Aircraft Industries

## INFORMATION BULLETIN

**IB No.: L410UVP-E/528b Revision 1**

**Subject:** Change wiring of loads on the S1A, S2A, S2B, S3B power buses.  
Change of yellow marked circuit breakers on the overhead panel.  
Clarification of brushes installation of the LUN 2132.02-8 starter/generator.

Fig. 1 Correct position of brushes in a holder

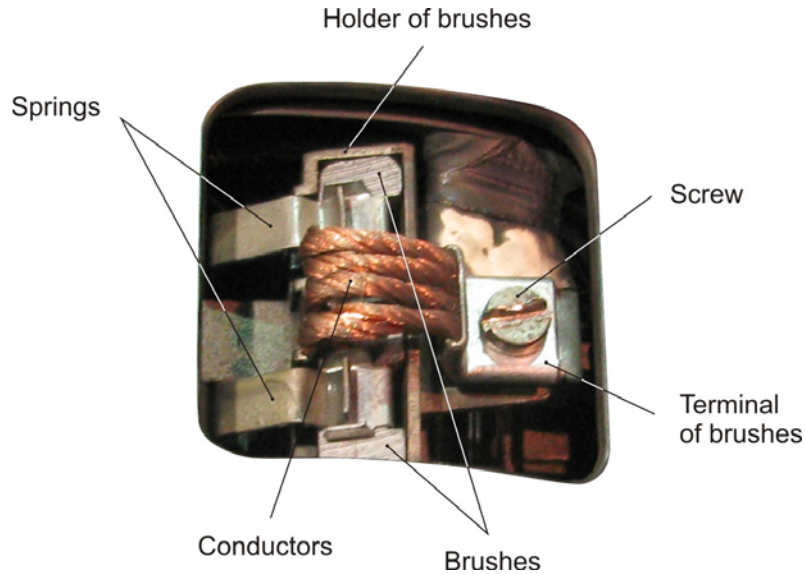
### Clarification of brushes installation of the LUN 2132.02-8 starter/generator

- Check after installation of the starter/generator brushes (after the check for brush wear according to the MM of GE M601E/E-21 engine, chap. 80.11.00, page 501 or MM of GE H80-200 engine, chap. 80.10.01, page 203) – see Fig. 1:
  - tightening of screws connecting the brushes terminals with brushes holders
  - correct position of brushes terminals – perpendicular to the axis of commutator rotation
  - arrangement of conductors – they must not be crossed nor frayed

- integrity and setting of springs in the U-profiles on upper side of brushes
- free smooth motion of the brushes in holders

1 EL. SCHÉMA – GENERÁTOR / AKUMULÁTOR

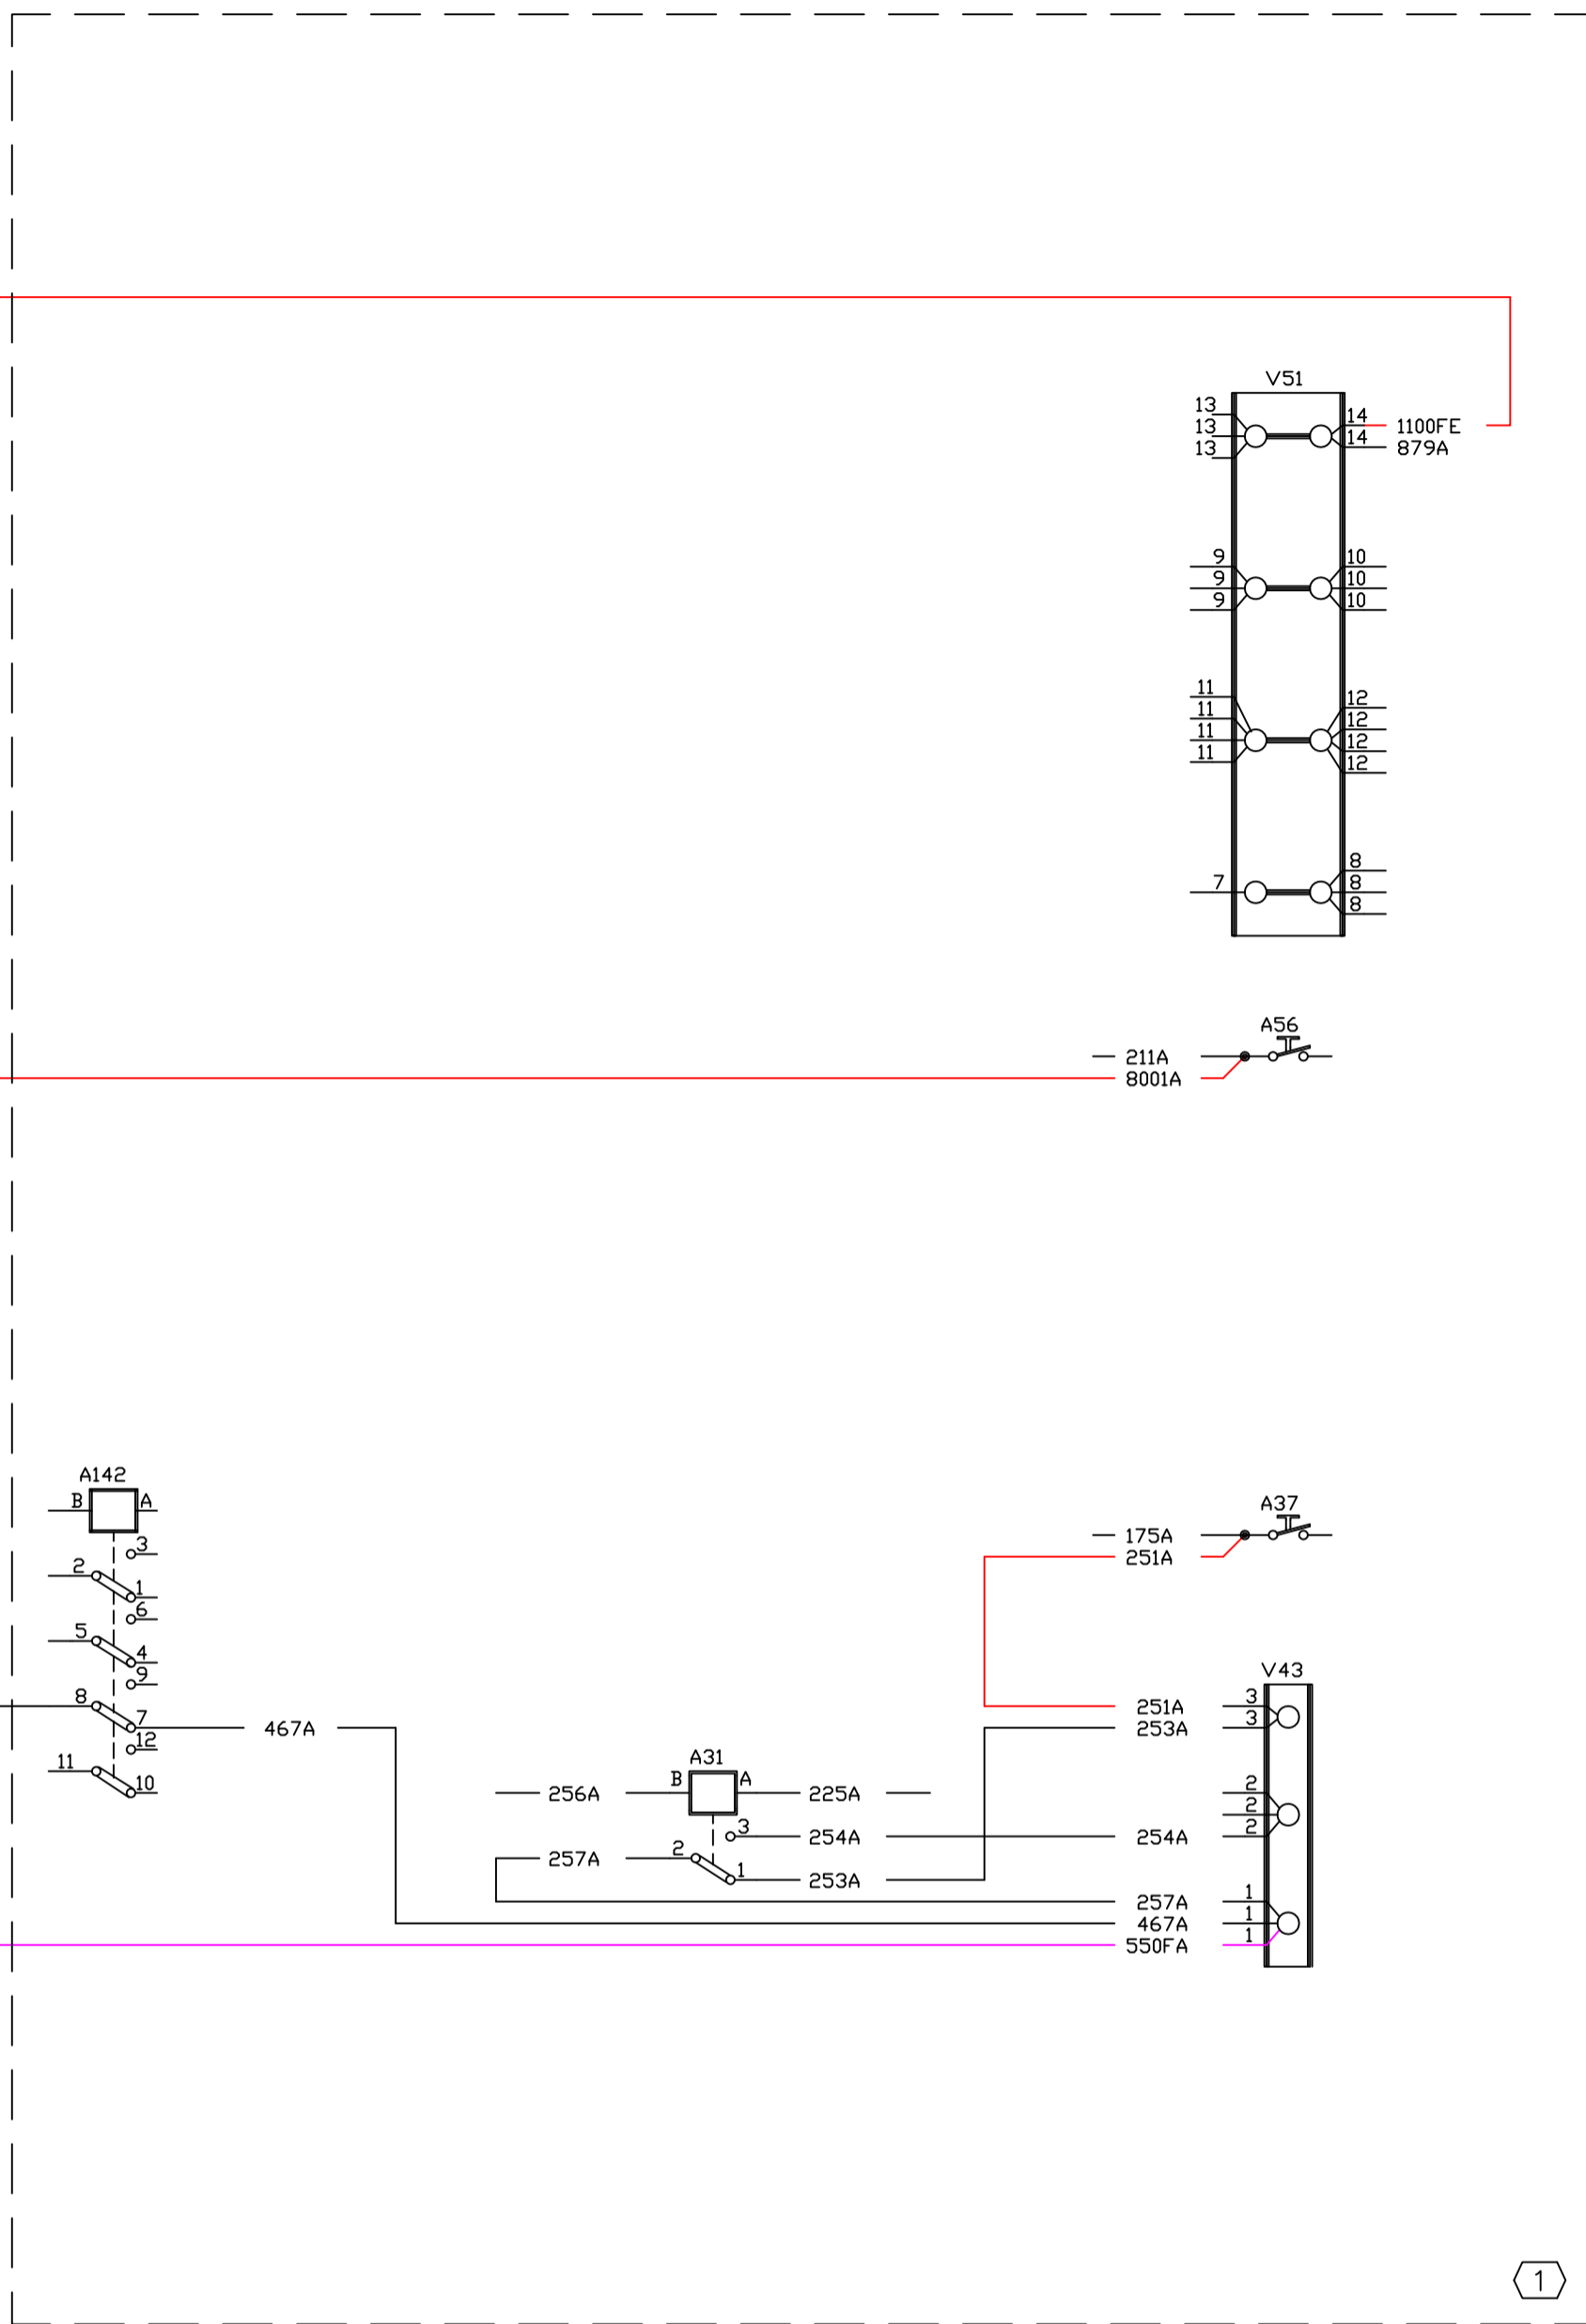
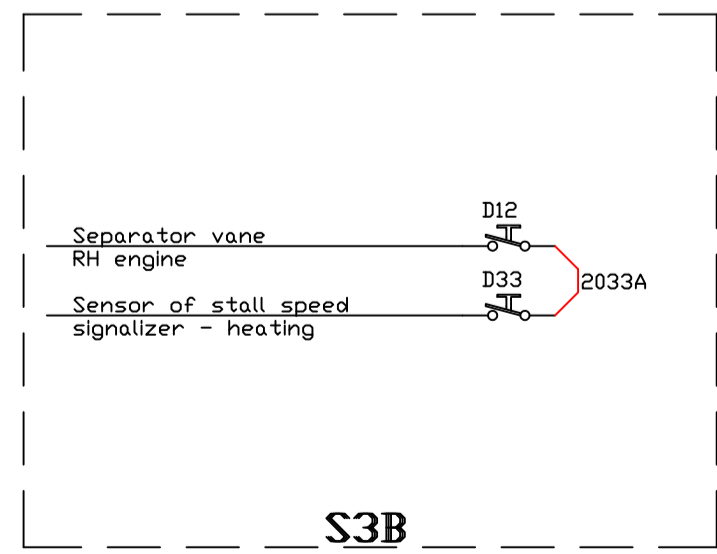
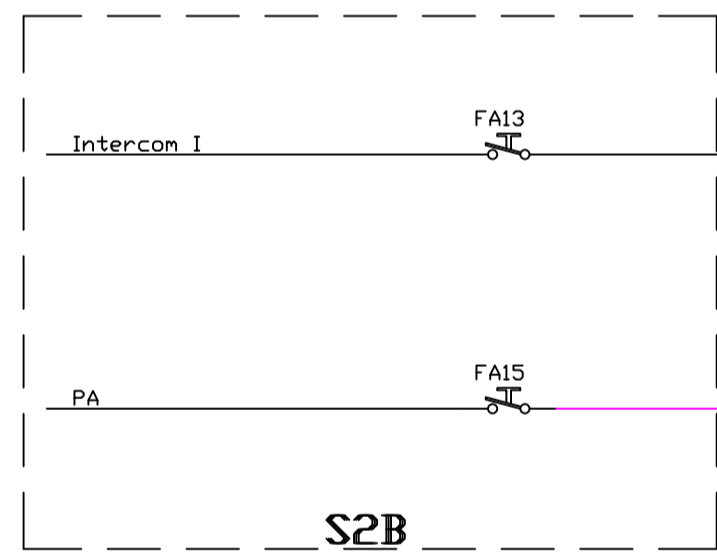
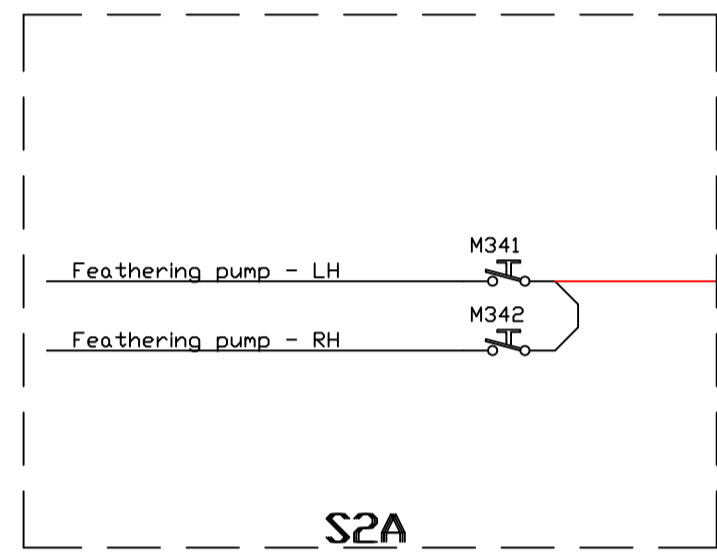
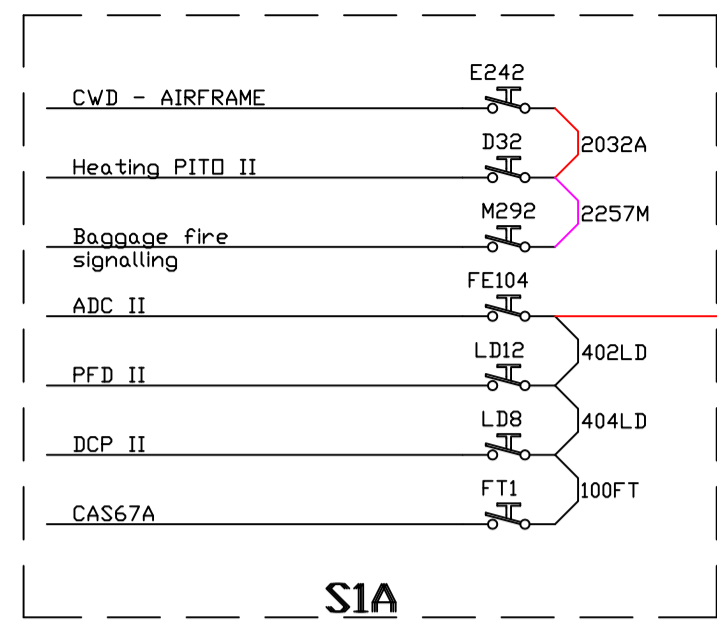
- Connect the new 2032A, 2033A, 2257M, 8001A, 1100FE, 550FA wires acc. to the B570 956X wiring diagram. Verify conformity with the B570 606X wiring diagram. Fasten the wires to the existing harnesses. Use material pos. 1, 3, 4 of point 3.A. of this bulletin.
- Disconnect the 251A wire from the A38 circuit breaker and connect it to the A37 circuit breaker (between bulkheads 1 to 2, RH).

- Connect the new 2257M, 550FA wires acc. to the B570 956X wiring diagram. Fasten the wires to the existing harnesses. Use material pos. 2, 3, 4 of point 3.A. of this bulletin.
